Product Change Notification

Change Notification #: 113323 - 00
Change Title: Intel® Server System R2208GZ4GS9
PCN 113323-00, Product Design
Update the System Rear Panel, Resistors and
Capacitors
Date of Publication: October 29, 2014

Figure One

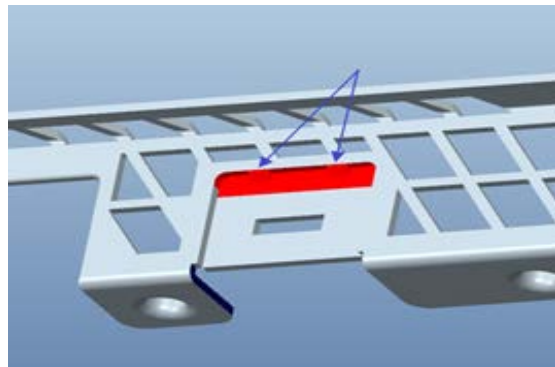
1. Update the one big center joint to two smaller joints so that the joints will not conflict with the LAN cable connector latch. See the Figure One.

Figure Two

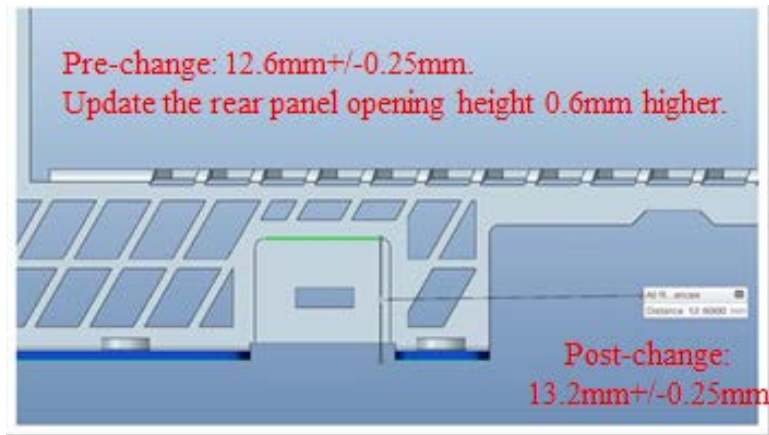
2. Update the rear panel opening height 0.6mm higher to improve the flexibility for the cable latch. The previous height was 12.6mm \pm 0.25mm. The updated height is 13.2mm \pm 0.25mm. See the Figure Two.

Figure Three

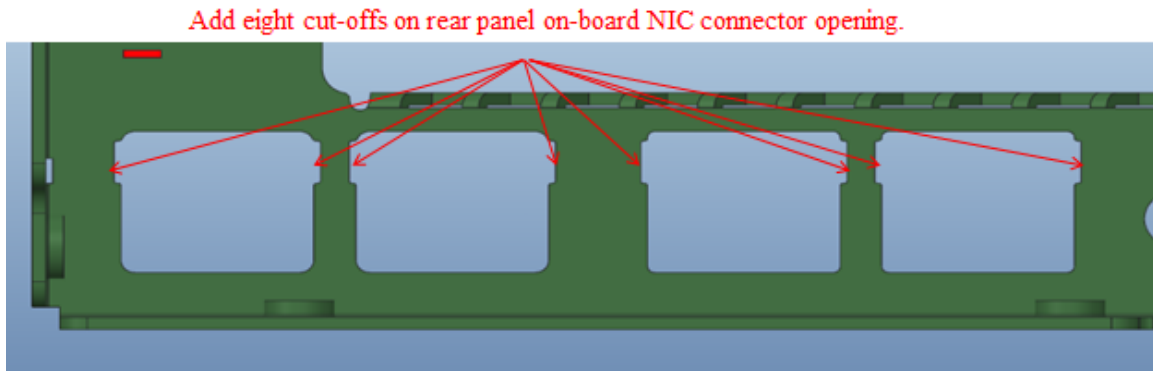
3. Add eight cut-offs around the on-board NIC (Network Interface Controller) openings to improve the LED visibility. See the Figure Three.

Figure Four. Component Locations for the 2U Riser Spare A2UL8RISER

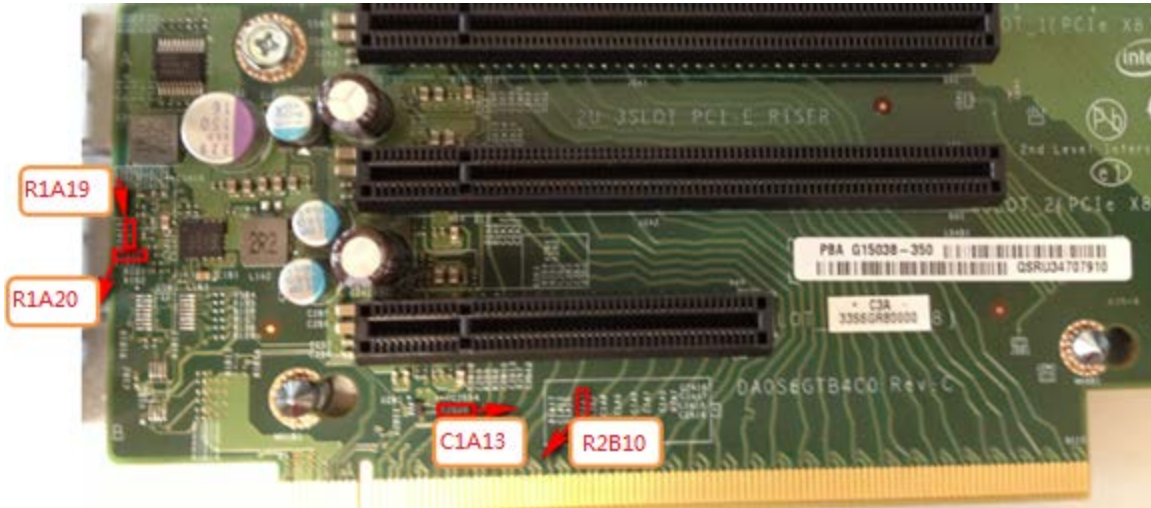
4. Update the following resistors and capacitor (see Table One and Figure Four) on the 2U PCIe Riser Spare A2UL8RISER to make an improvement to support a higher 3.3 Voltage Regulator startup over current. Before this change, the Voltage Regulator on the riser card may not be able to turn on when the total current drawn is more than 5A current. After this change, the Voltage Regulator on the riser card can support more than 10A current.
